REFERENCE:	Nova Bus Manuals
SECTION:	09: Engine and Cooling
RS N°:	MQR 7621-2169
EFFECTIVE IN PROD.:	N/A
TC RECALL N°:	2021-568
NHTSA RECALL N°:	20V INFORMATION REDACTED PURSUANT TO THE FREEDOM OF INFORMATION ACT (FOIA), 5 U.S.C.552(B)(6)

SUBJECT:	Power steering
JUSTIFICATION:	Certain power steering pipes may separate at the connection joint. This may cause a power steering assist lost and power steering fluid spillage from the ceiling in the cabin.

LEVEL	DESCRIPTION	DIRECT CHARGES		TIME
		LABOUR	MATERIAL	
1	Replace hydraulic pipe N77549-01.	Nova Bus	Nova Bus	10.5 h
2	-	-	-	-

Figure 5 - Hydraulic Pipe N77549-01

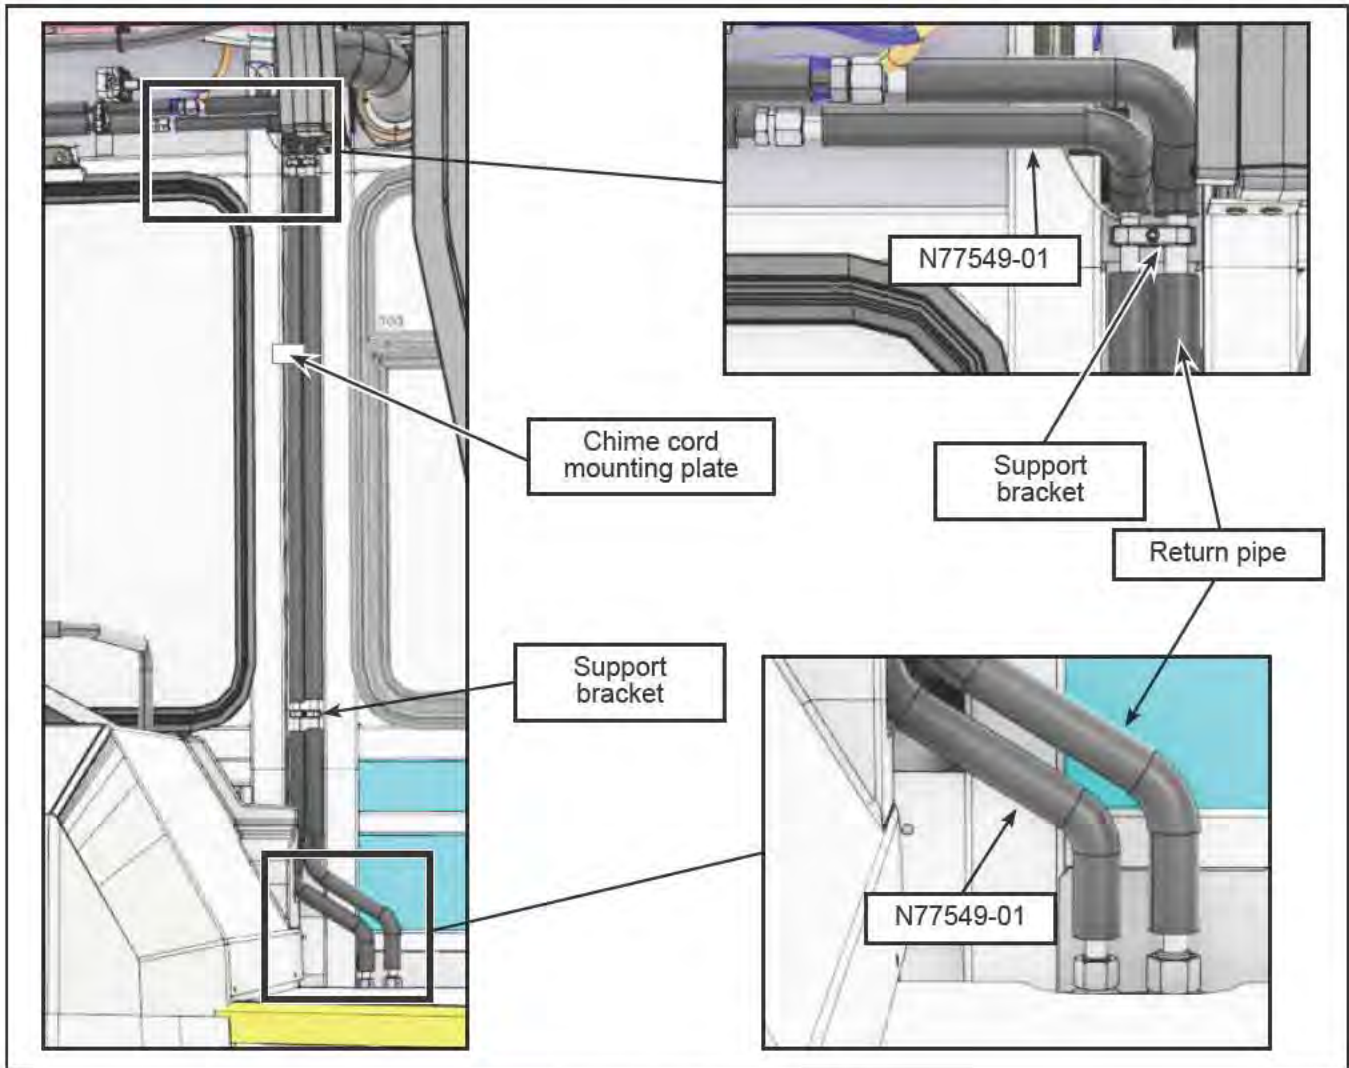
- Locate hydraulic pipe N77549-01 (Figure 5).
- Remove the 2 support brackets.
- In order to remove the hydraulic pipe N77549-01, it is necessary to first remove the return hydraulic pipe located next to it because of the presence of the chime cord mounting plate (Figure 5).
 - Disconnect the ORS fitting at each end of both pipes (note: a small amount of oil will pour).
 - Remove the return pipe.
 - Remove the pipe N77549-01.

- Install new insulation N26360 on the new hydraulic pipe N77549-01 as on the old one.
- Install the pipe N77549-01 in the vehicle and hand tighten the ORS fittings.
- Reinstall the return hydraulic pipe and hand tighten the ORS fittings.
- Tighten the 4 ORS fittings to the torque value of 48 lb-ft (65 N·m).

- Reinstall the 2 support brackets.
- Discard the old hydraulic pipe N77549-01.
